Addendum 1

Project Stadium New Press Box – Marlin ISD
Issued January 26th, 2024 by CEI Engineering Associates, Inc.
Proposal Opening February 6th, 2024 at 2:00 PM

Item 1 – Press Box Concrete Design Changes

PRESS BOX GRADING PLAN
SHEET TITLE
SHEET NUMBER

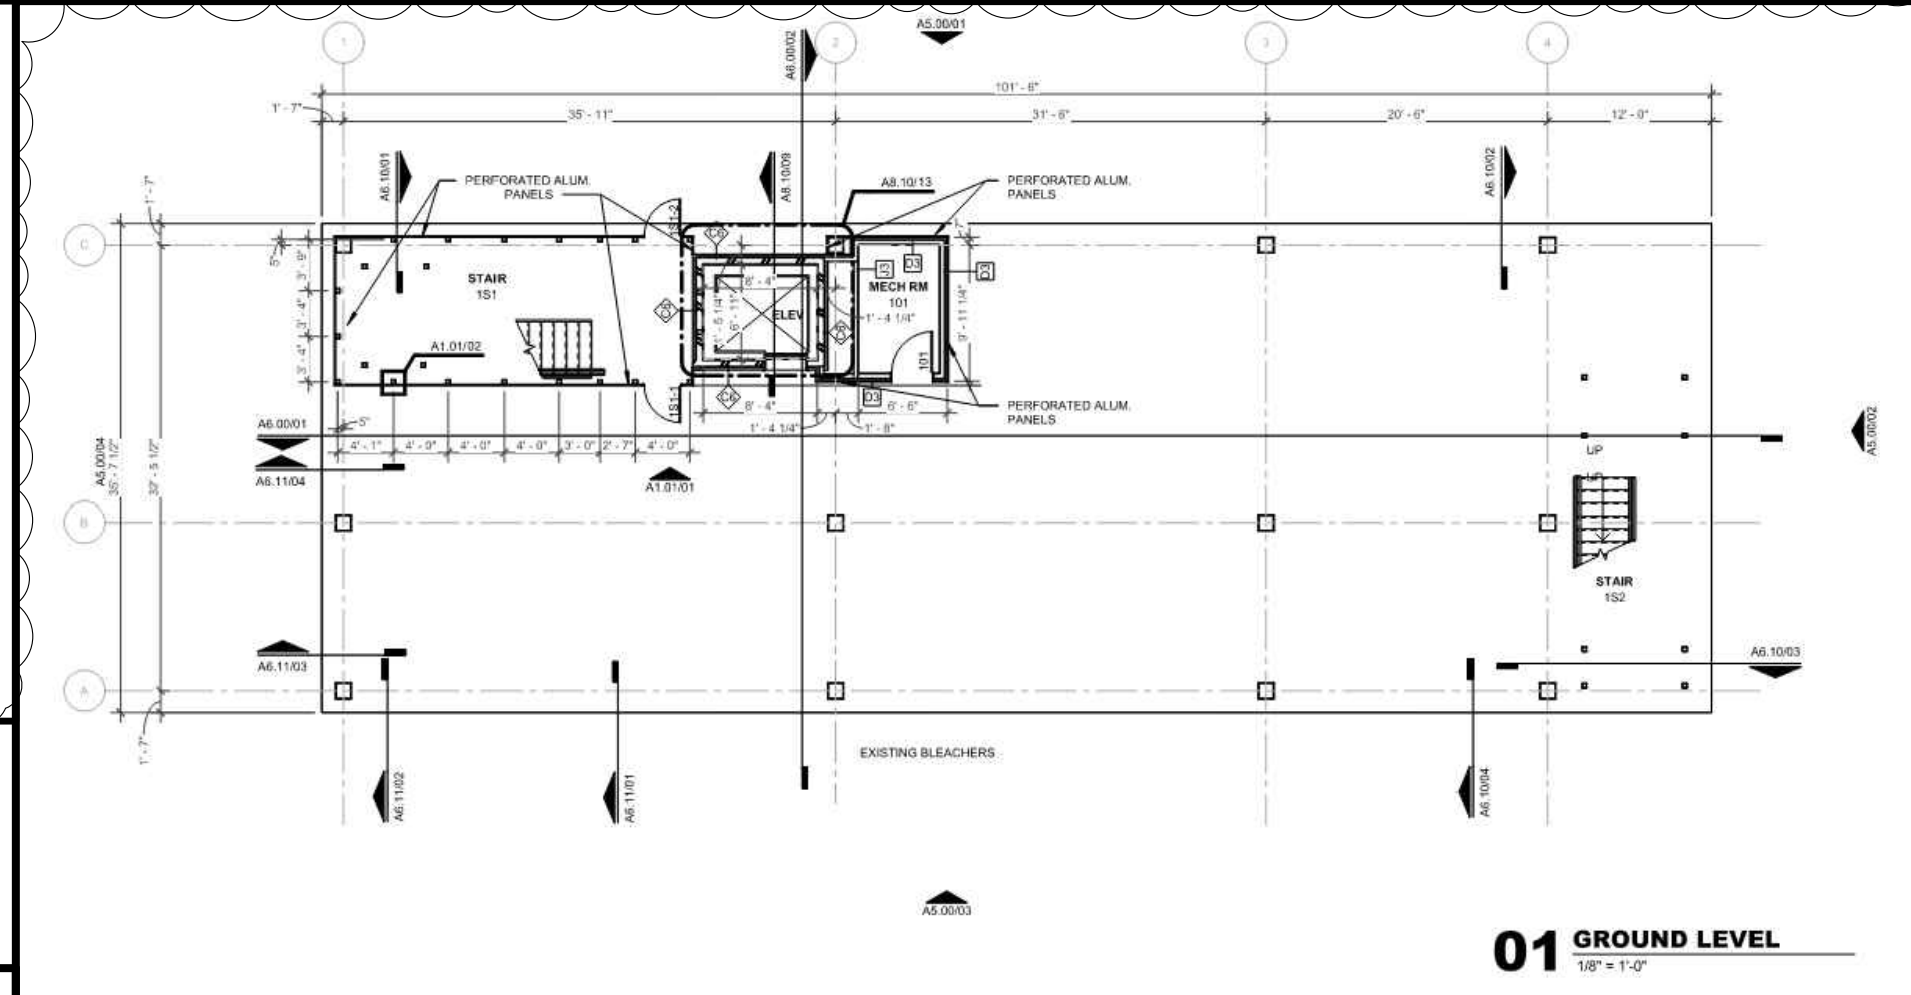
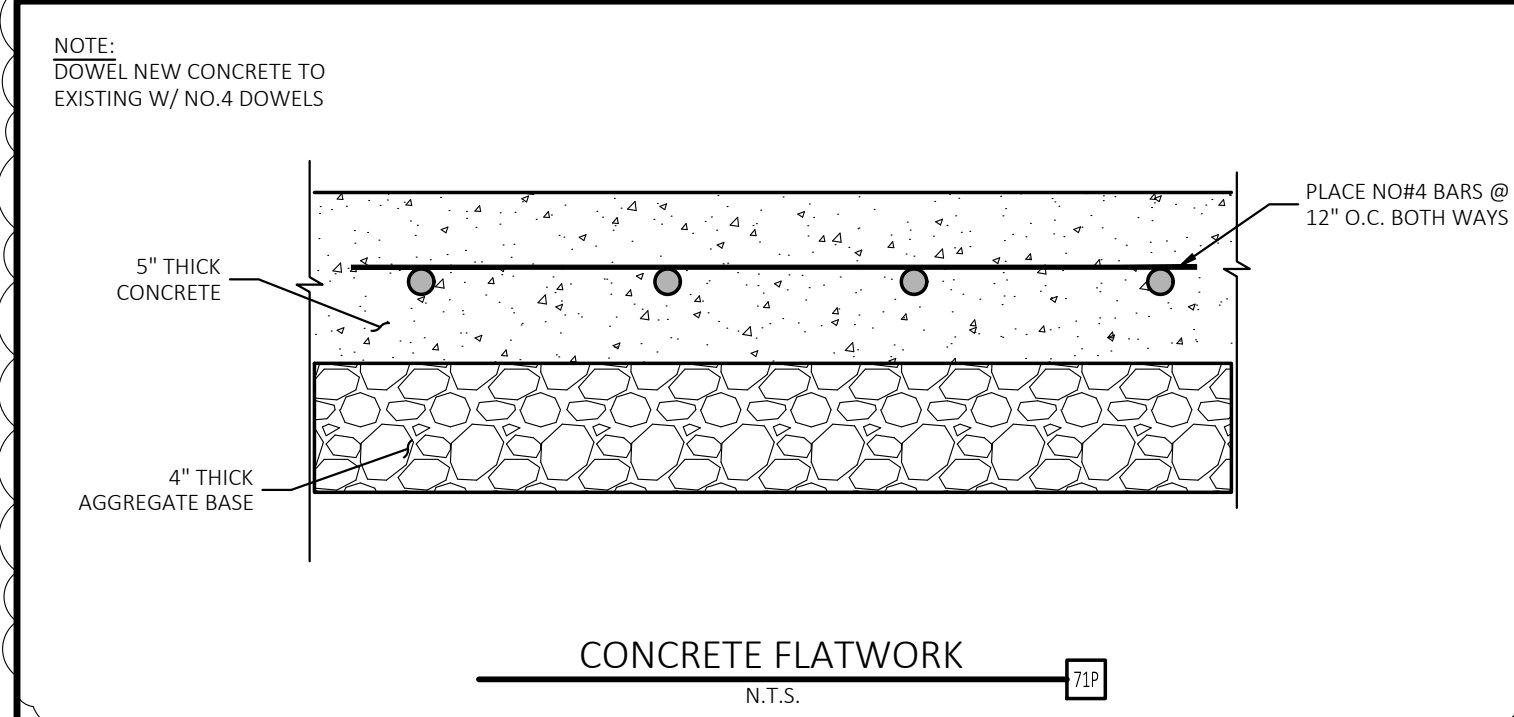
1. Concrete flatwork directly beneath and immediately adjacent to the press box (as detailed on the attached drawings) is being added to this contract. Installation of plaza concrete to be coordinated with site work contractor.

NOTE: THE SITE WORK IMPROVEMENTS SHOWN HEREON WITH THE EXCEPTION OF THE FLATWORK INDICATED TO BE INCLUDED UNDER THIS CONTRACT SHALL BE PROVIDED BY OTHERS. CONTRACTOR SHALL COORDINATE THEIR WORK WITH THE WORK OF THE OTHER CONTRACTORS THAT WILL BE TAKING PLACE CONCURRENTLY WITH THE WORK OF THIS CONTRACT.

LIMITS OF CONCRETE FLATWORK TO BE PROVIDED UNDER THIS CONTRACT, PER DETAIL 71P. AREA OF CONCRETE FLATWORK = 13,829 S.F.
